RS-04-069

April 30, 2004

LaSalle County Station, Units 1 and 2  
Facility Operating License Nos. NPF-11 and NPF-18  
NRC Docket Nos. 50-373 and 50-374

Subject: License Amendment Request  
Activation of the Trip Outputs of the Oscillation Power Range Monitor System

Figure 3.4.1-1, "Power versus Flow," and associated references to the figure from the LCO, Actions, and SRs are deleted.

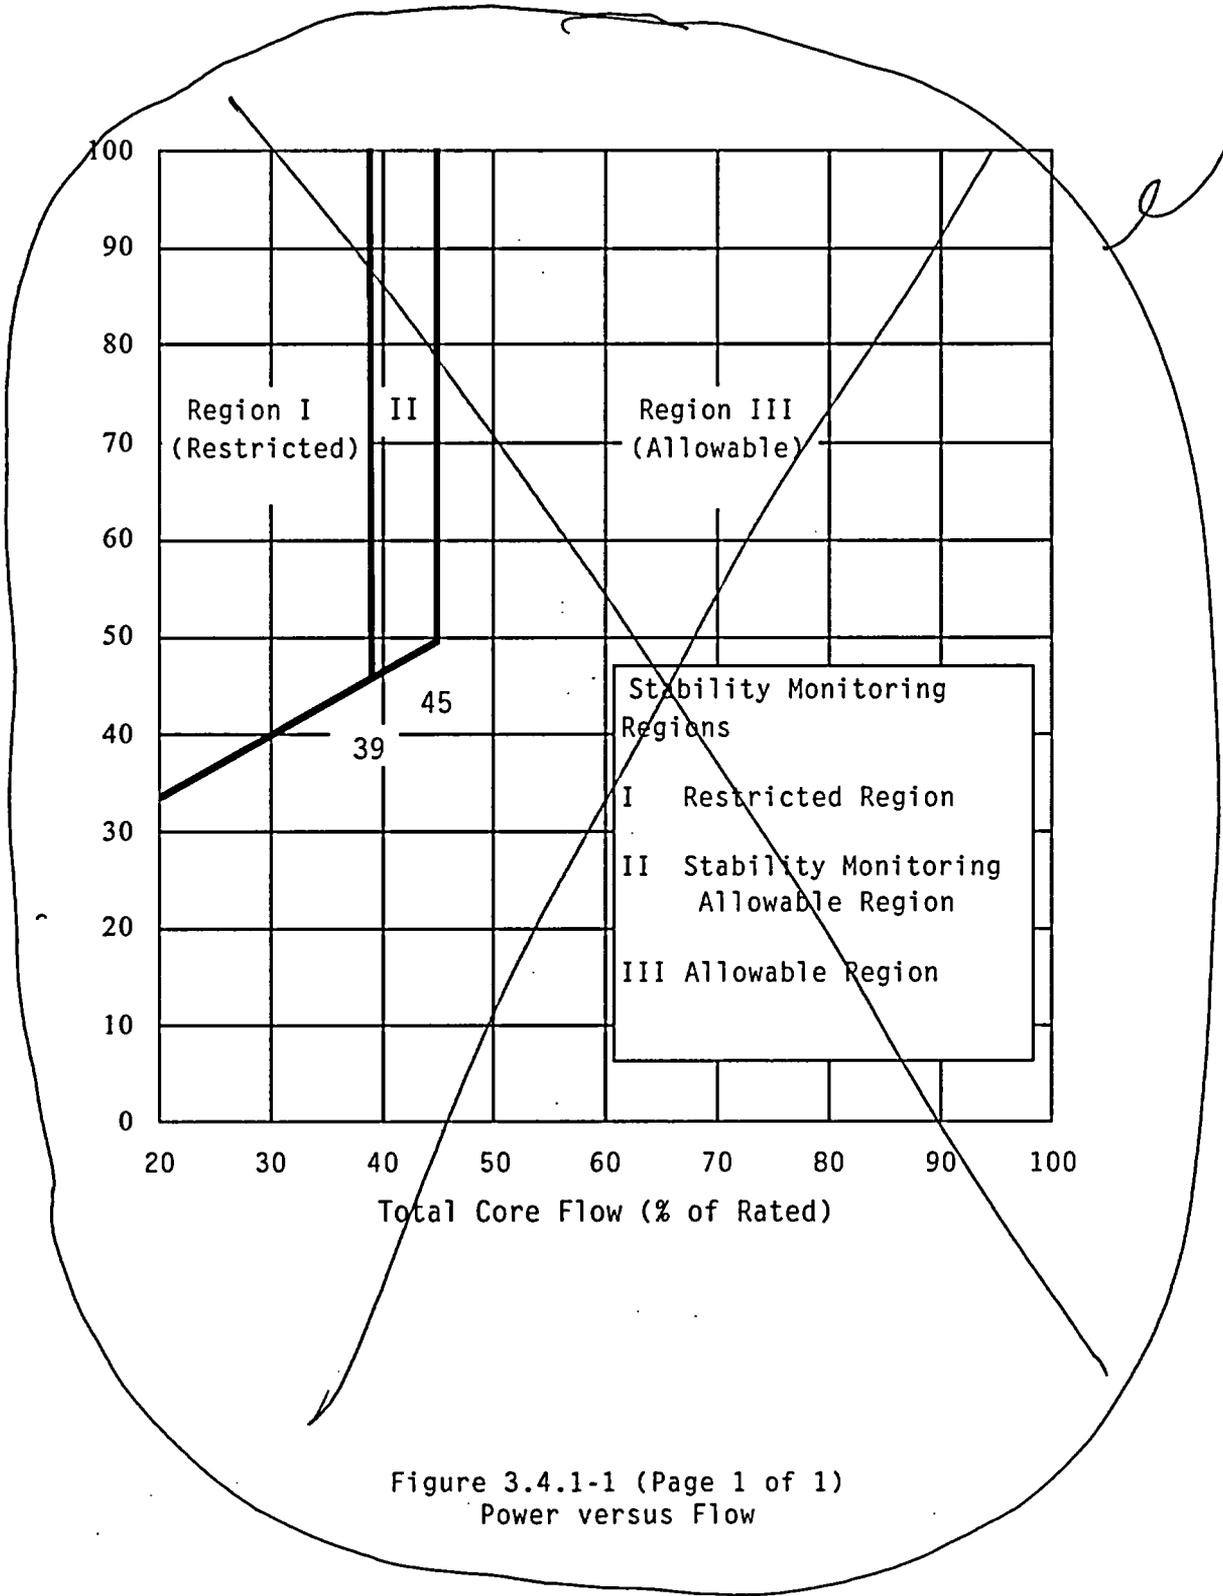
LCO 3.4.1 Two recirculation loops with matched flows shall be in operation, ~~within Region III of Figure 3.4.1-1~~

One recirculation loop shall be in operation ~~within Region III of Figure 3.4.1-1~~ with the following limits applied when the associated LCO is applicable:

CONDITION	REQUIRED ACTION	COMPLETION TIME
<p>A: <del>One or two recirculation loops operating within Region II of Figure 3.4.1 1</del></p>	<p>A.1</p> <p><del>-----NOTE----- Only applicable when 3 times baseline value is &gt; 10% peak-to-peak value. -----</del></p> <p><del>Verify APRM and LPRM flux noise levels &lt; 3 times baseline.</del></p> <p><del>AND</del></p>	<p><del>45 minutes</del></p> <p><del>AND</del></p> <p><del>Once per 12 hours thereafter</del></p> <p><del>AND</del></p> <p><del>45 minutes from discovery of Condition A concurrent with any THERMAL POWER increase of <math>\geq 5\%</math> RTP</del></p> <p><del>(continued)</del></p>

The incorporation of the OPRM instrumentation into the TS will allow the deletion of the Power versus Flow TS Figure and associated references. The OPRM Instrumentation will provide at least the same level of assurance that the MCPR safety limit will not be violated for anticipated oscillations as that provided by the current stability requirements in the LCS TS.
